CITY OF PROVIDENCE, RHODE ISLAND

RFP Title: HVAC and Electrical Upgrades at Two Fire Stations

Addendum #: 4

Addendum #4 – Responses to Bidder Questions

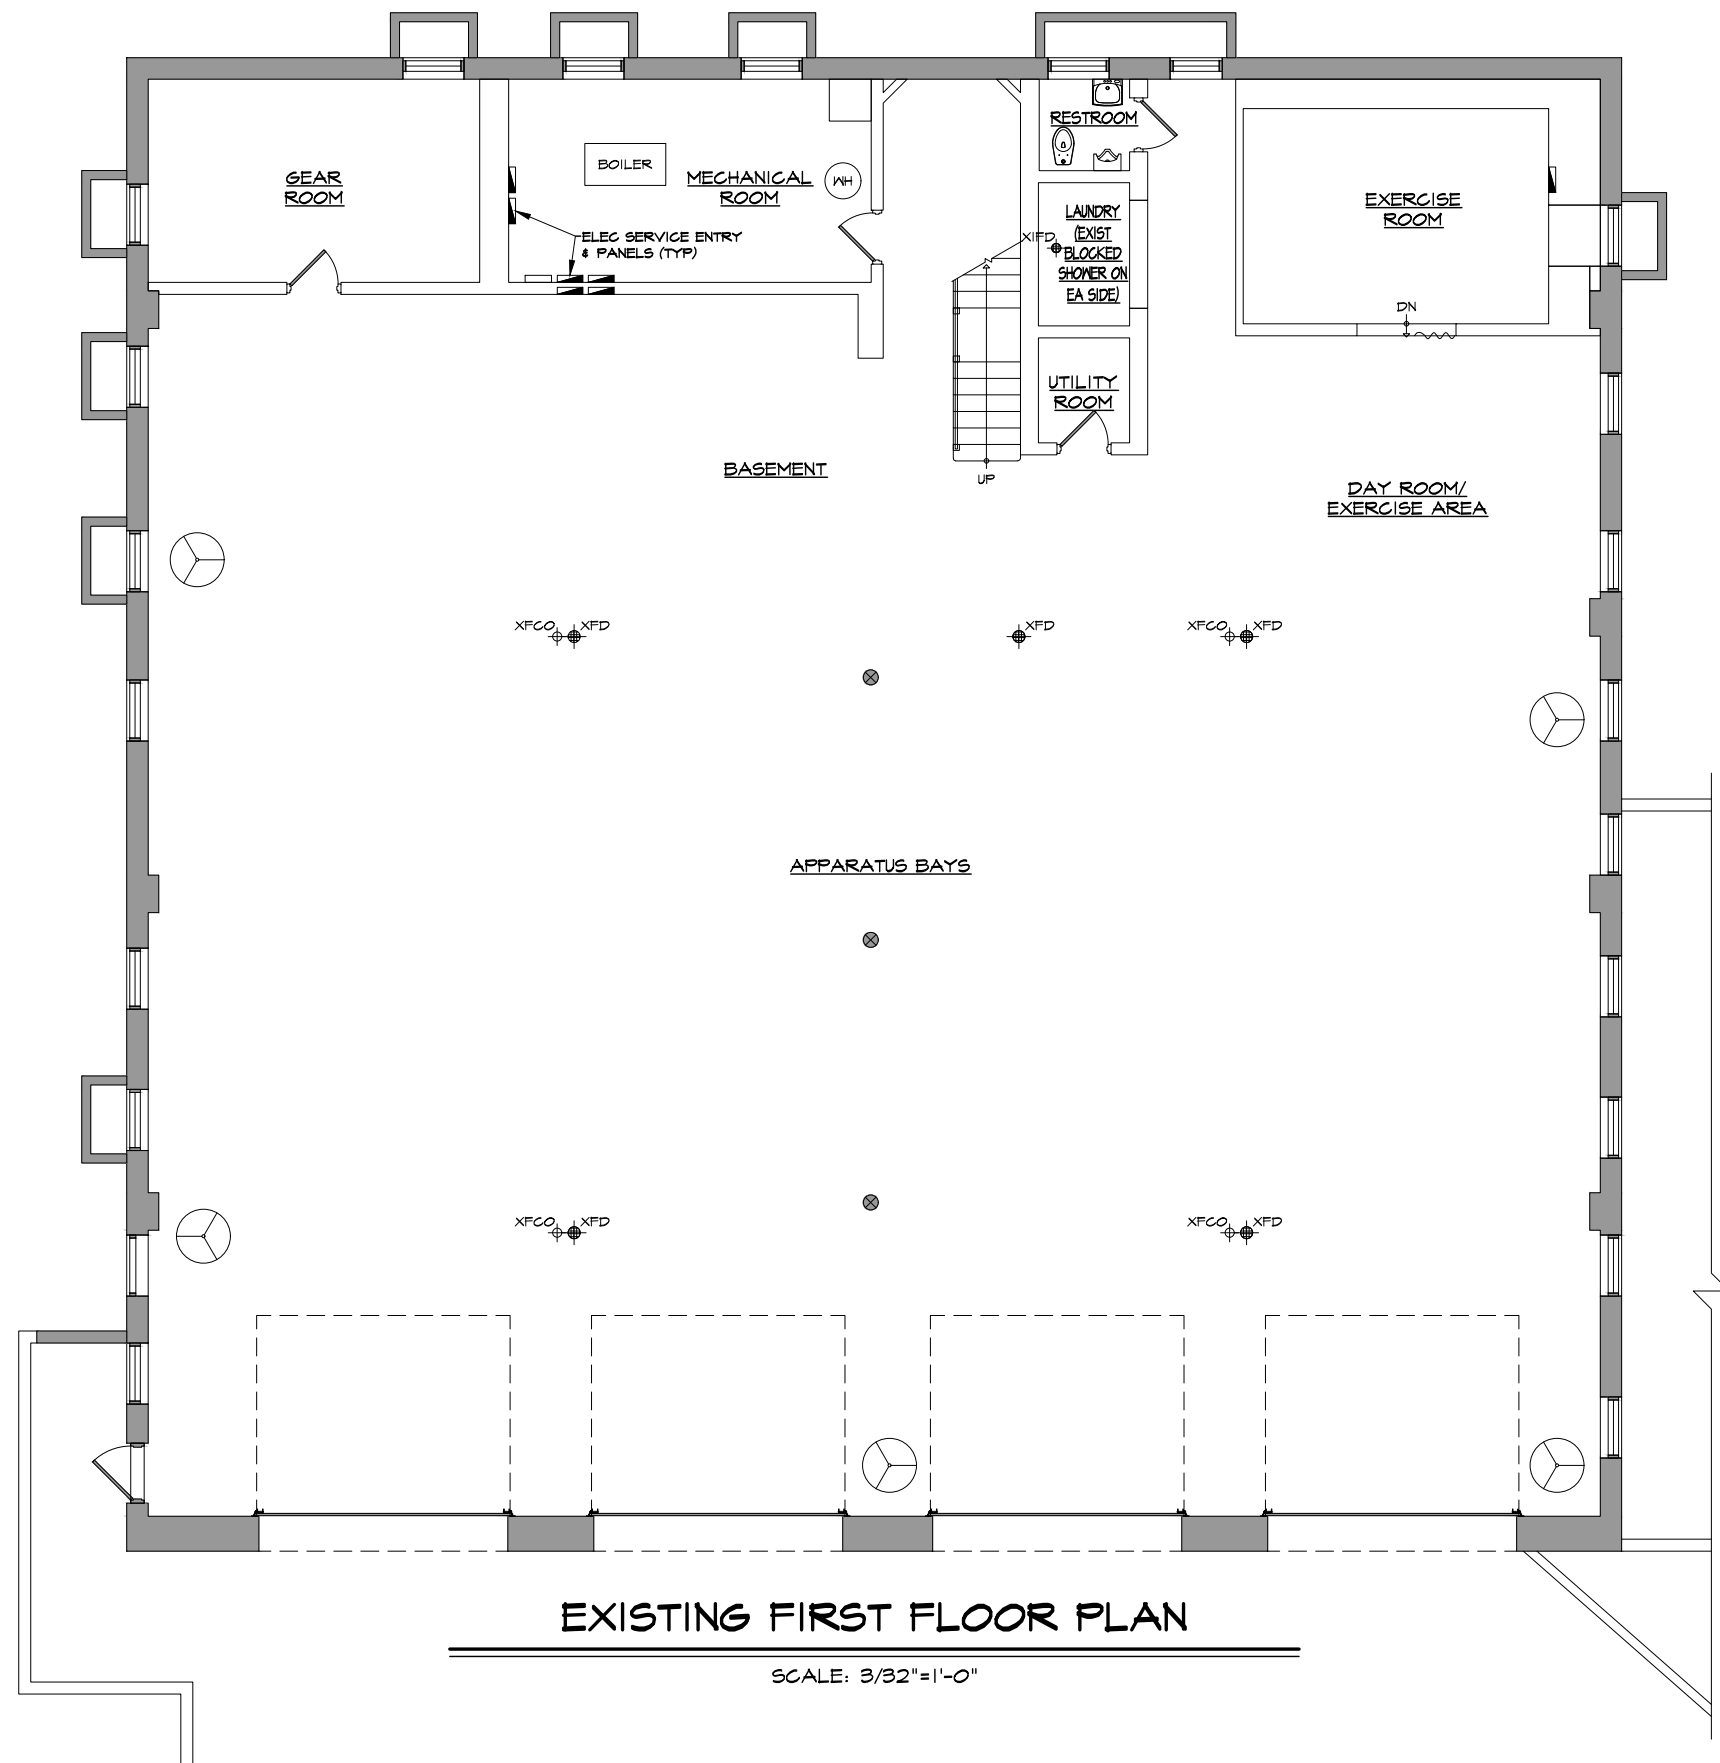
16) Can you provide a contact for Cummins (generator). I was unable to get Cummins to respond to RFP. Please review proposed alternate:

- **Engine Model:** Perkins 1106D-E70TAG4 180kW Standby Power Rating at 1800 RPM Governor - Electronic Isochronous
- **Voltage:** 208/120V 3 Phase 60 Hz 0.8 PF

A: The City's design team at Creative provided the following response:

Per the generator specification please see below:

"Proposals by other manufacturers (Caterpillar, Kohler, Generac) must include a line-by-line compliance statement based on this specification."

Without this line by line comparison statement, this substitution was not reviewed. Bidders proposing an alternative generator set as part of their bid must ensure they include a line-by-line compliance statement based on this specification to be considered.

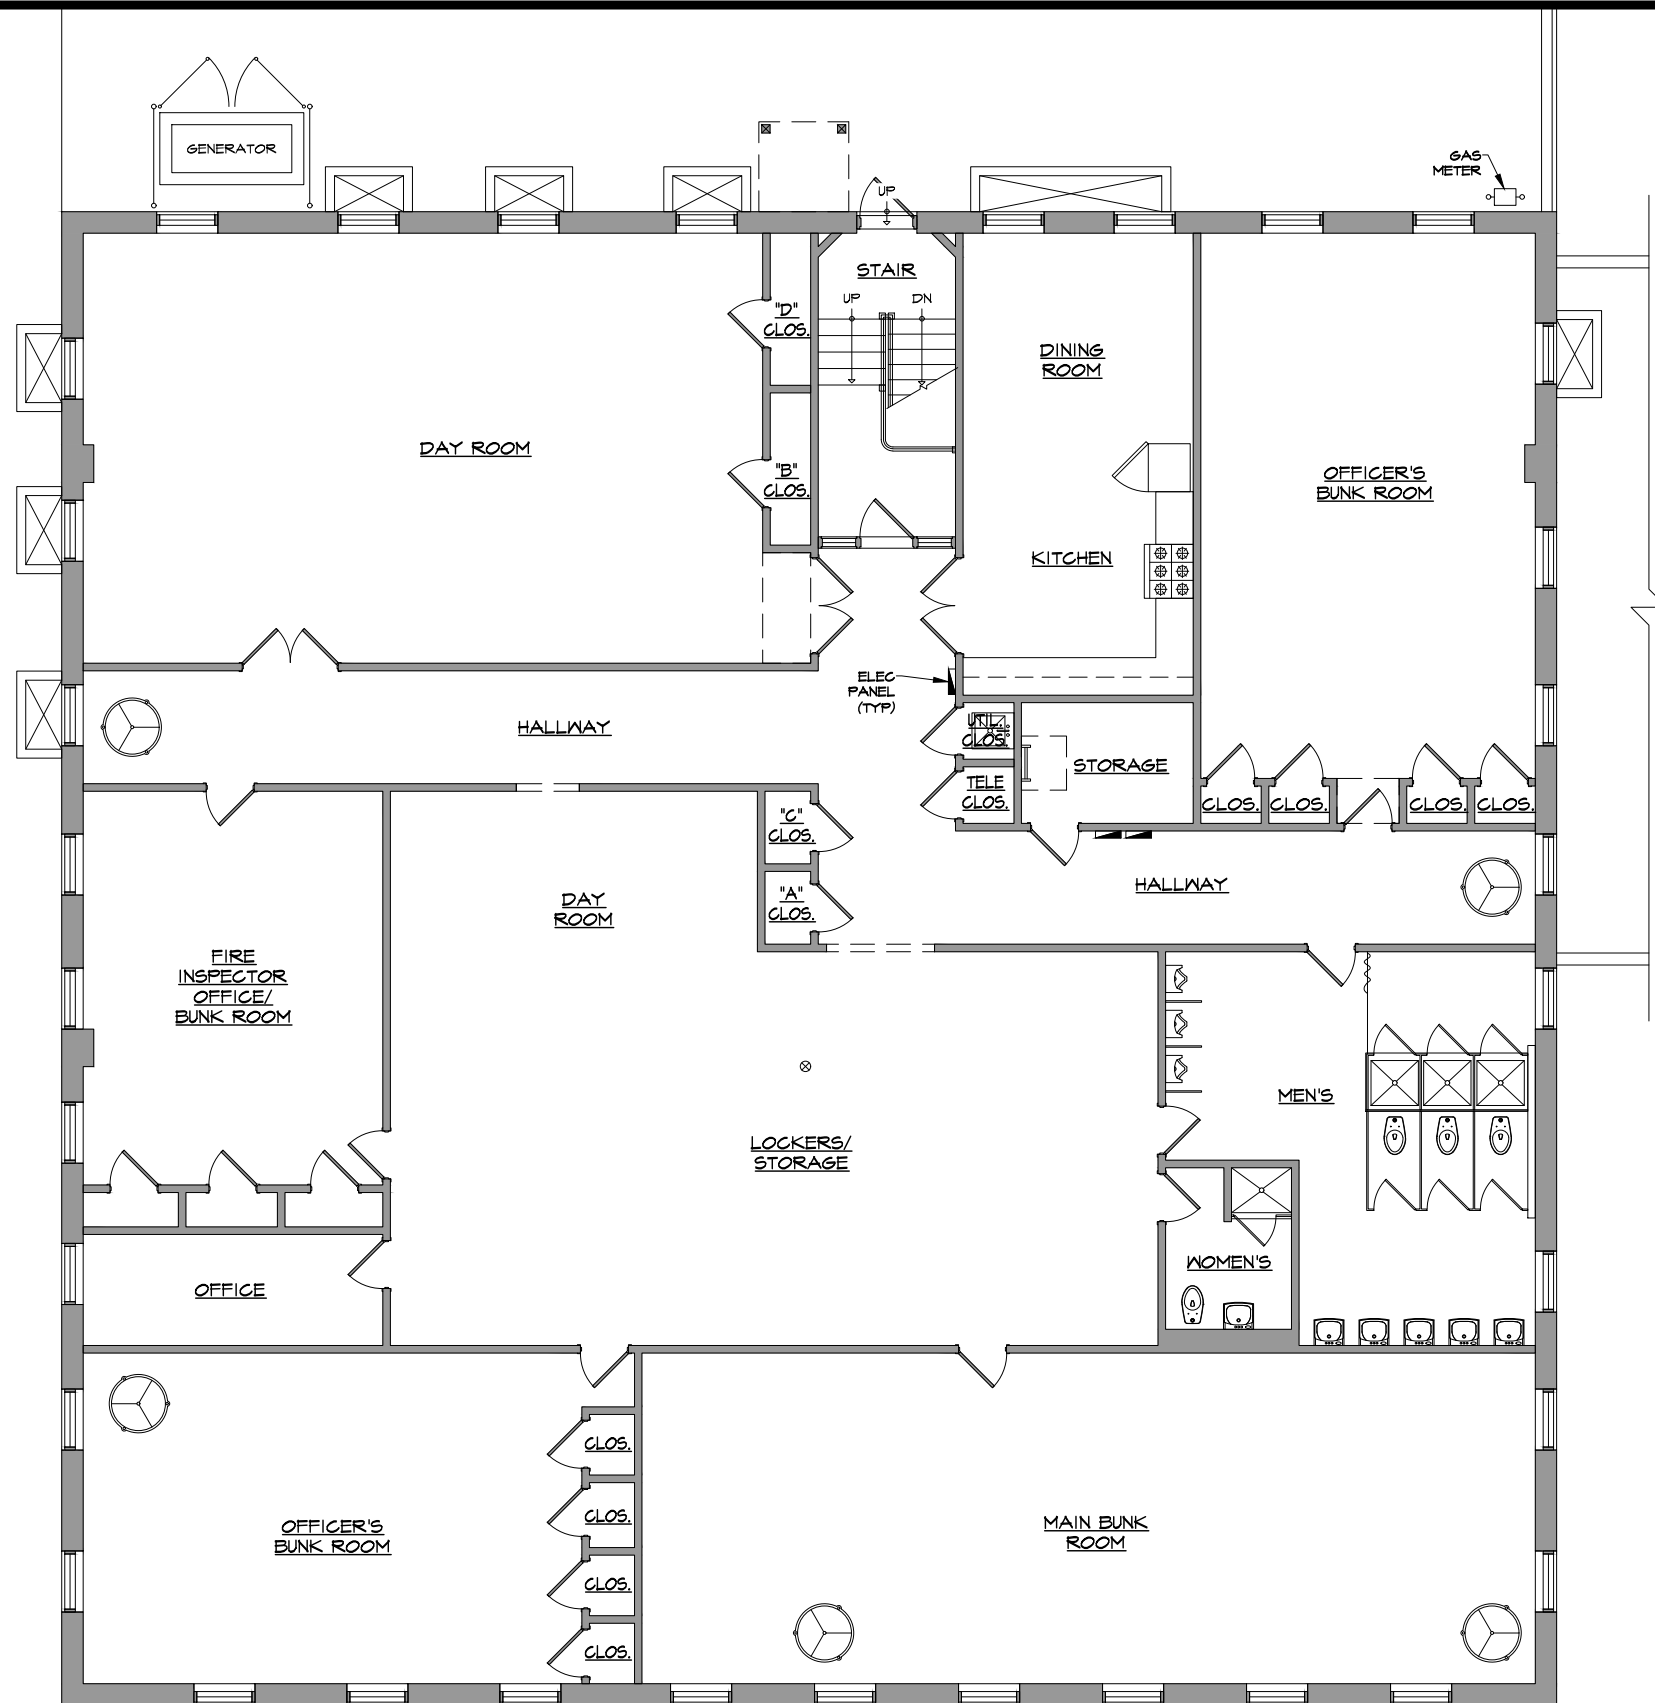
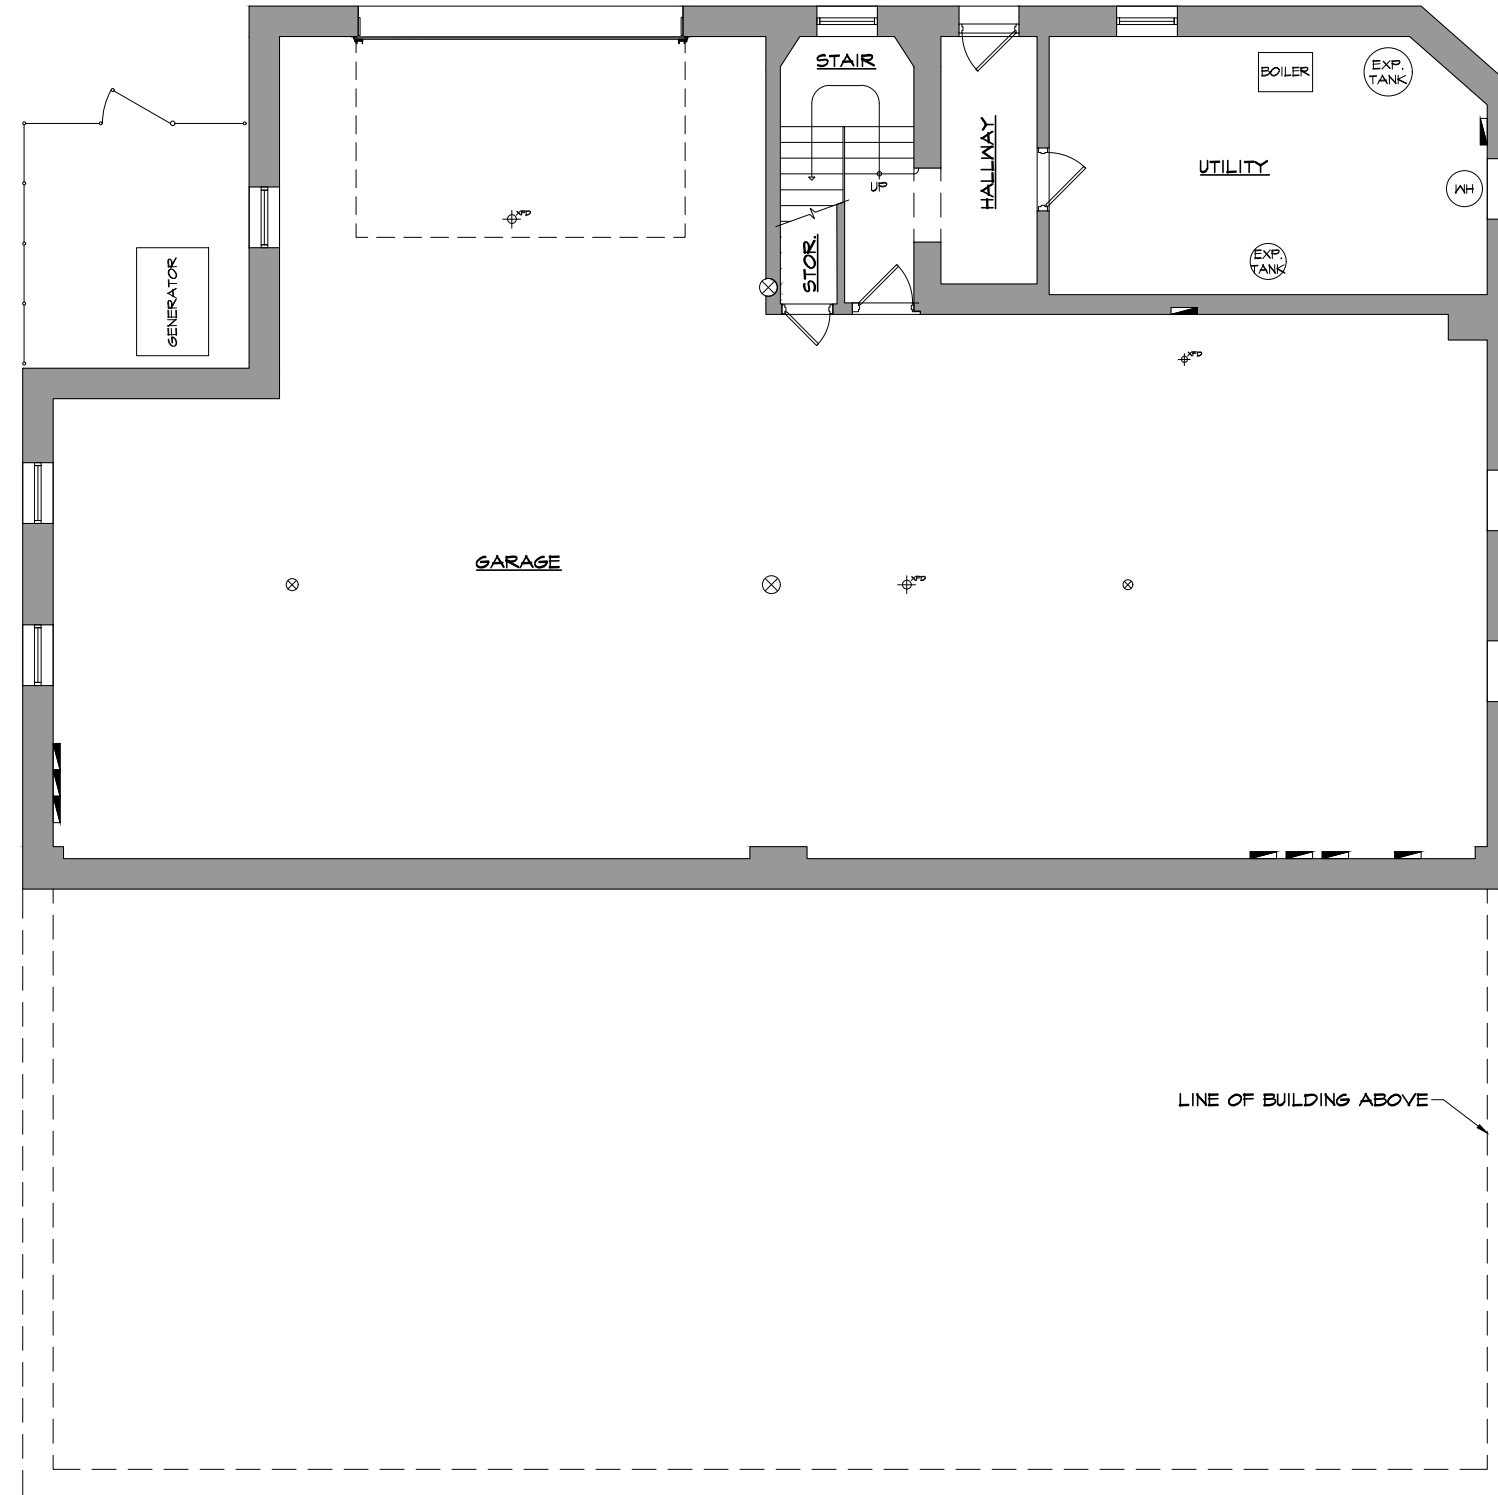
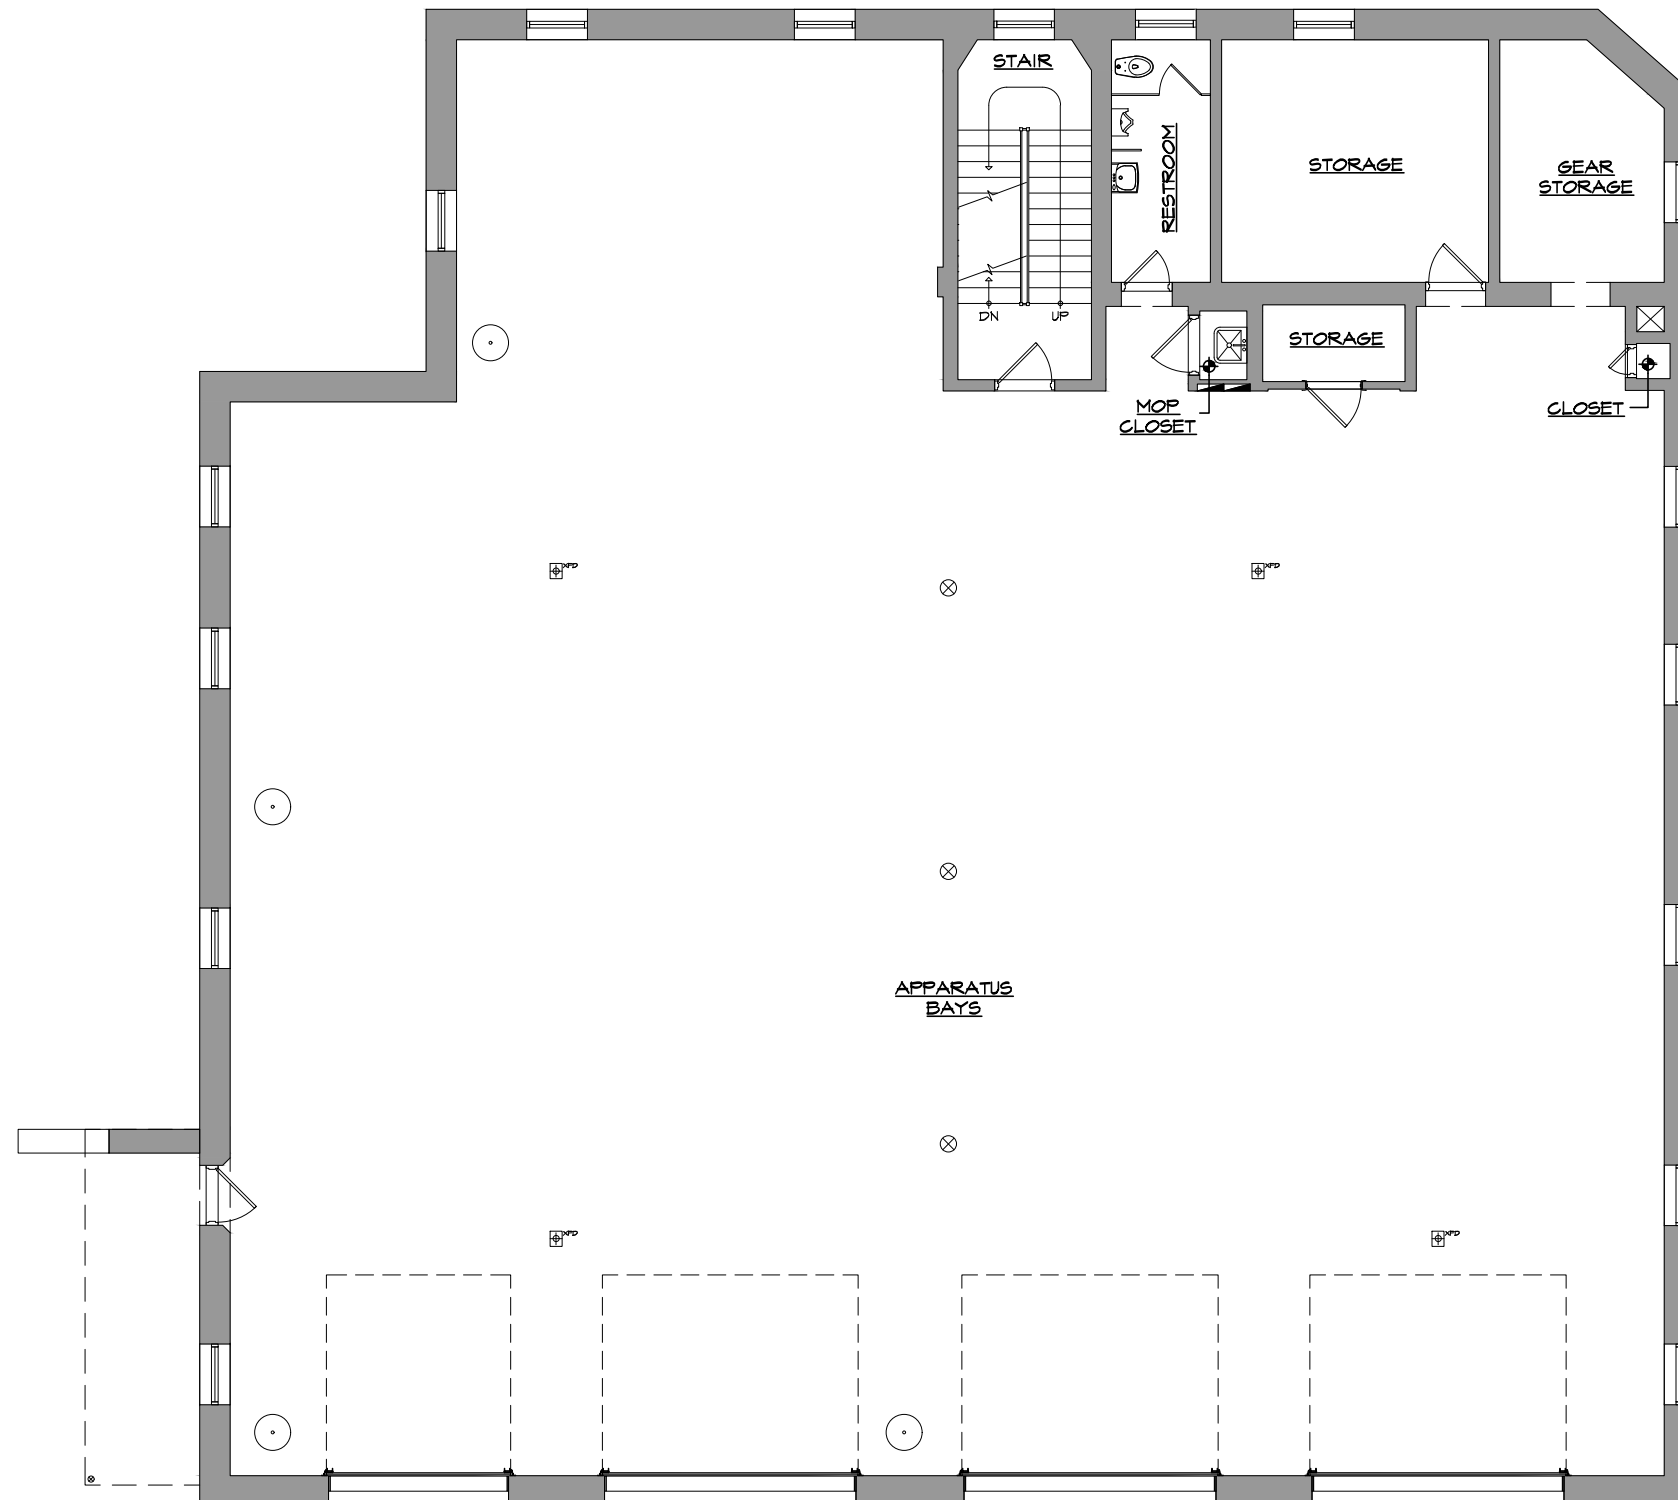
- 1) Are the Architectural drawings mentioned in the Plans available?

A: Basic floor plans developed during the fire station building evaluations are attached for bidder information.
